Agenda Item #2

Applications 2024-54-CA

2255 Ashland Place Avenue

Rebuild front steps; paint unpainted brick

Site Photos – 2255 Ashland Place Avenue

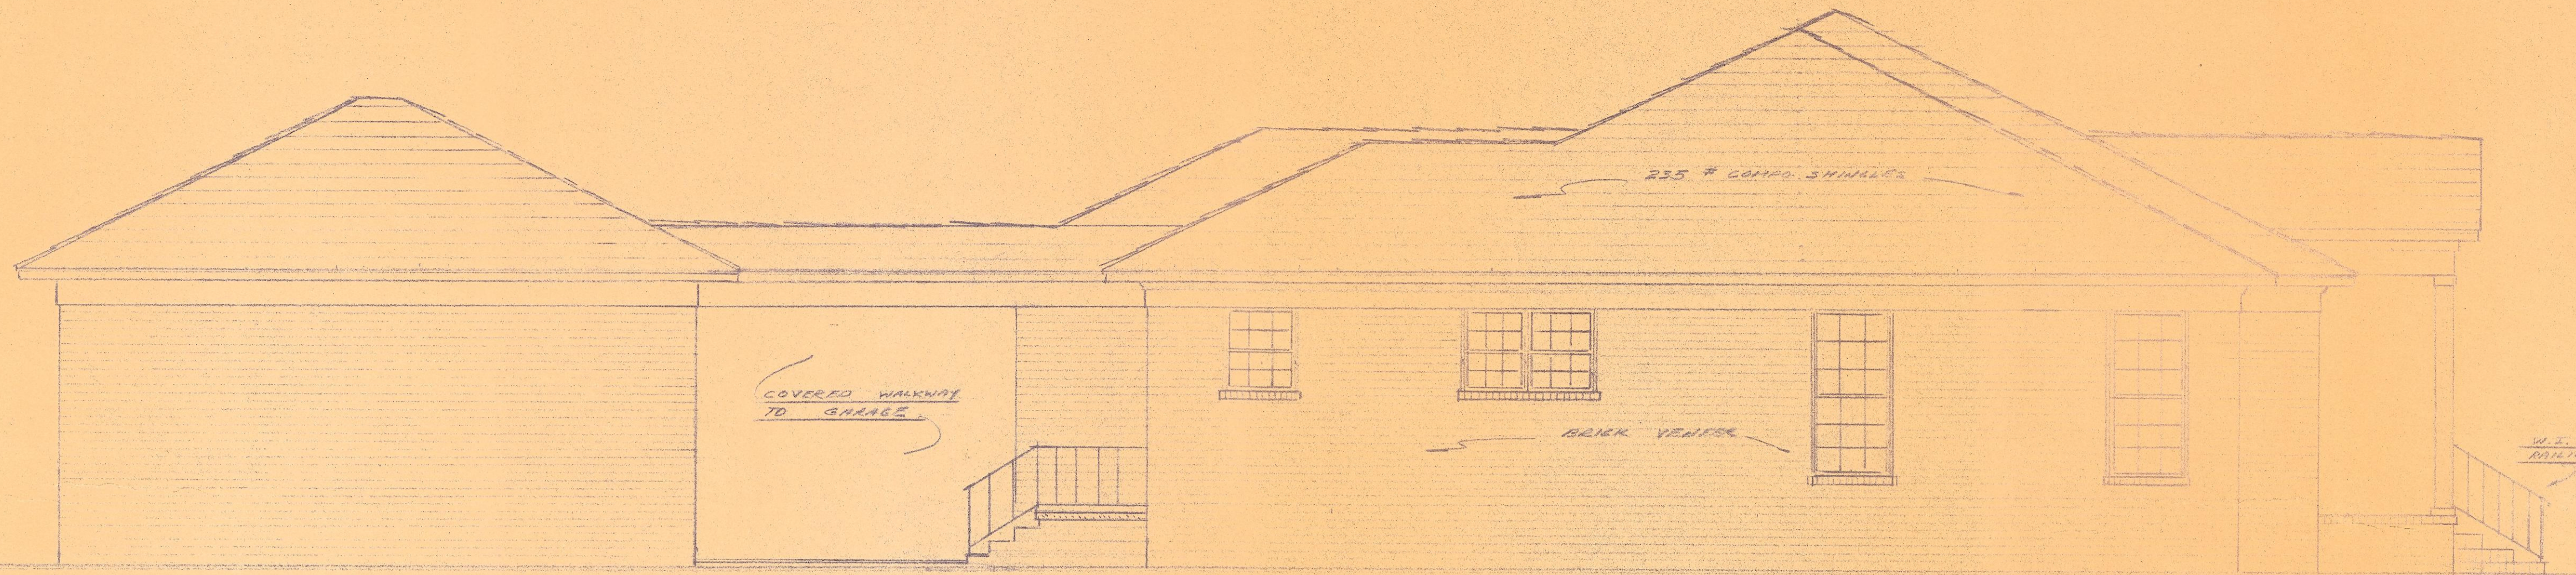
This application seeks approval to remove the existing porch stairs and replace them with a simpler single stair. In their request, the applicant expresses safety concerns in regard to the existing curved staircases. The applicant proposes replacing these stairs with a single broad stair centered on the north elevation of the entry porch. The application proposes adapting the original design for the porch stair, as seen in a c. 1967 architectural drawing, which featured a simple graduated brick stair in keeping with the restrained ornamentation of the Georgian Revival dwelling. The original design would need to be modified to fit the as-built residence, given the higher finished floor height of the extant dwelling compared to that shown in the c. 1967 drawing. The applicant has not provided details for modifications, but it appears that the proposed stair would require at least six steps instead of the three shown in the c. 1967 drawing.

The Guidelines strongly discourage replacing original porches or porch elements “unless absolutely necessary” and specifically warn against relocating a porch stair. If alterations are deemed necessary, the Guidelines state that replacement elements and materials should be “appropriate to the style, texture, finish, composition and proportion of the historic structure.” While the proposed work would violate both of the aforementioned directives, the new design would be wholly in keeping with the style of the historic structure. The applicant proposes a brick stair, which replicates existing materials, and would reuse portions of the existing wrought iron

FRONT ELEVATION

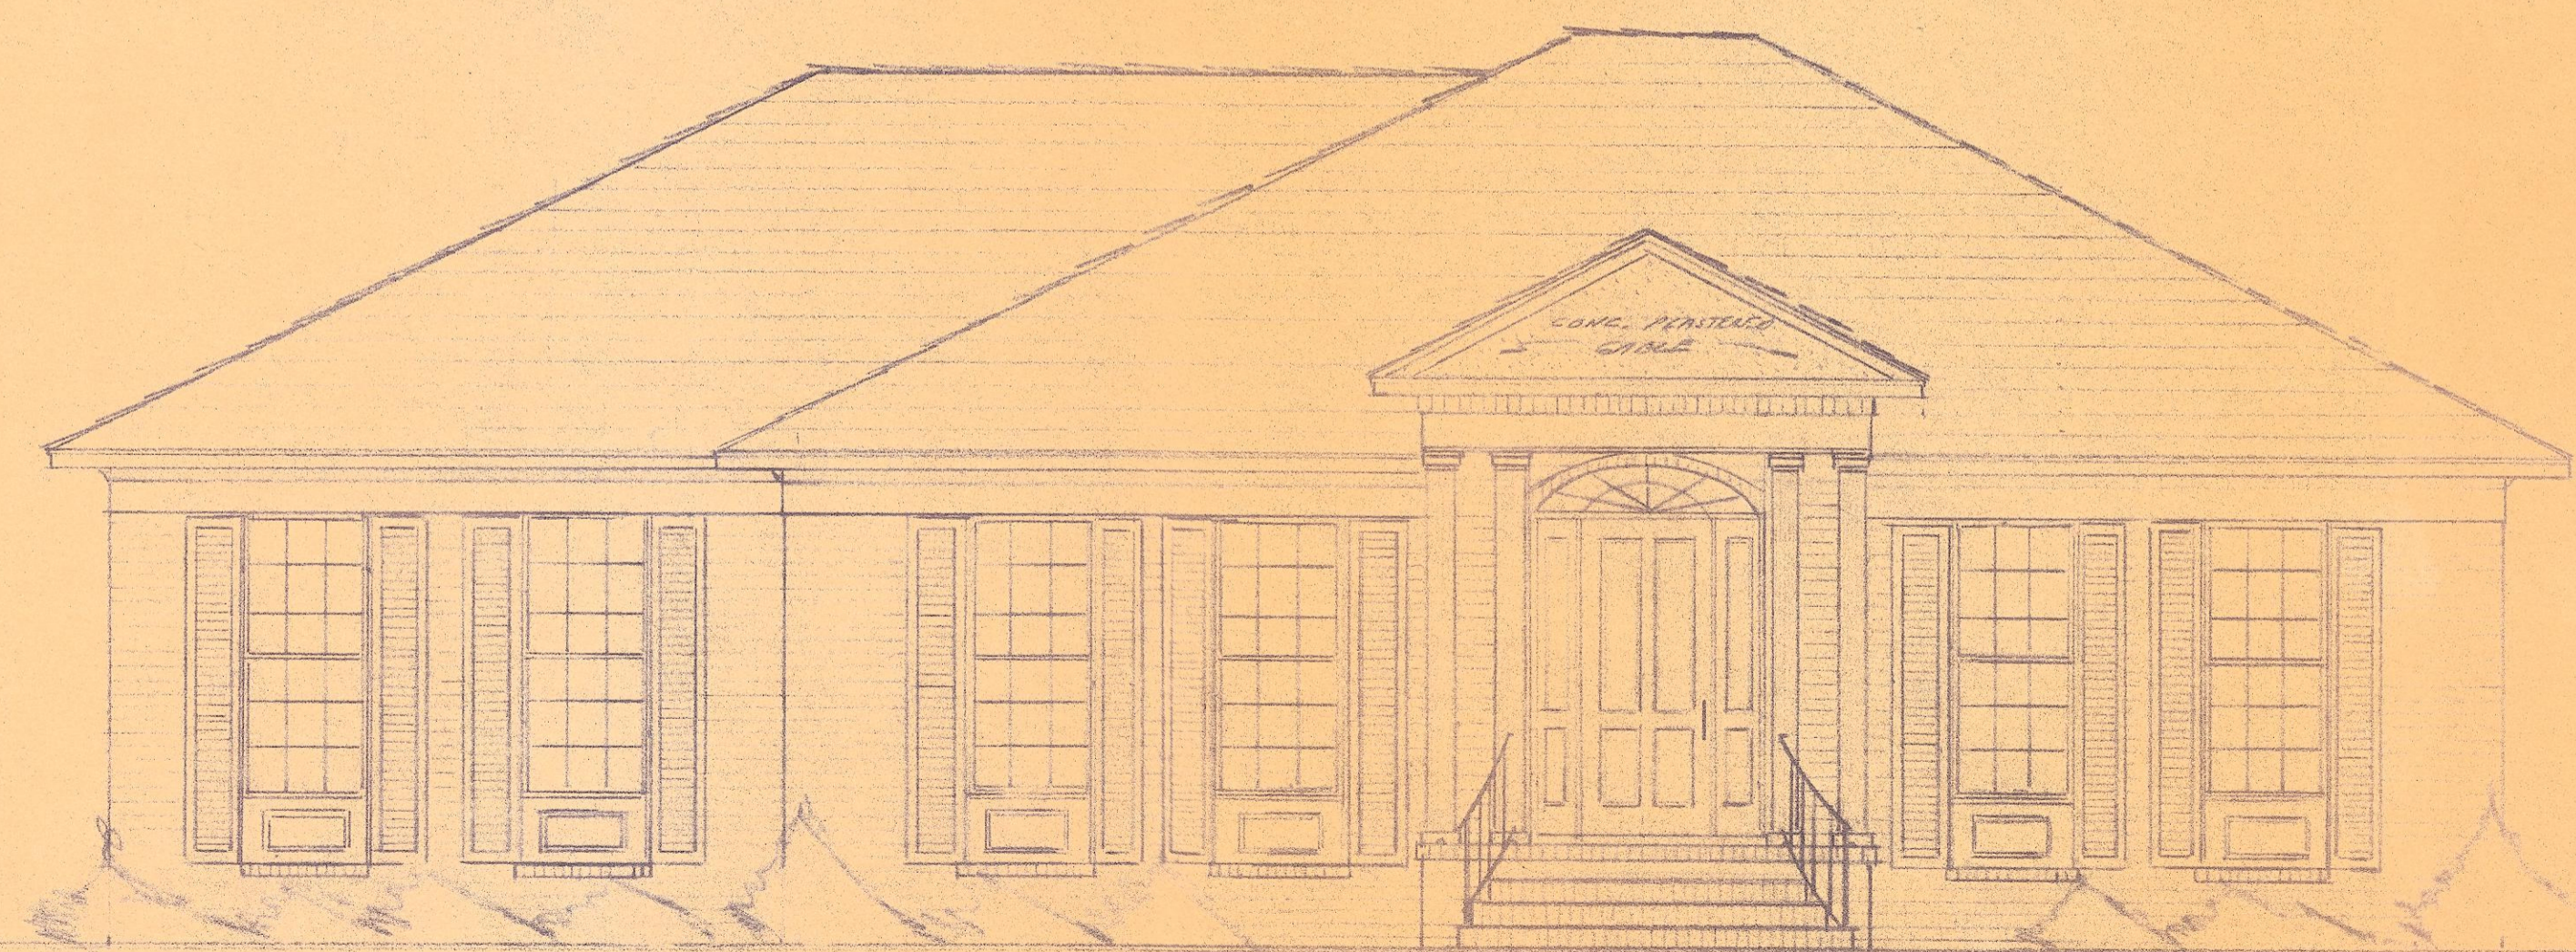
- The width of the bottom step would not exceed the width of the entry porch.
 - While the c. 1967 drawing depicts only 3 steps, the increased floor height of the existing porch would require at least 6 steps. Step widths would be modified as necessary to achieve a similarly graduated stair with a bottom step that is not wider than the entry porch.

- Portions of the salvaged wrought iron railing would be reinstalled on either side of the stair, in line with the railing placement shown in the c. 1967 drawing.

railing to create the handrails at either end of the proposed stair. Moreover, the existence of the original drawing ensures that a graduated central stair on the north elevation of the entry porch is perfectly in keeping with the architect's original design intent. (5.4, 6.4, 6.6)
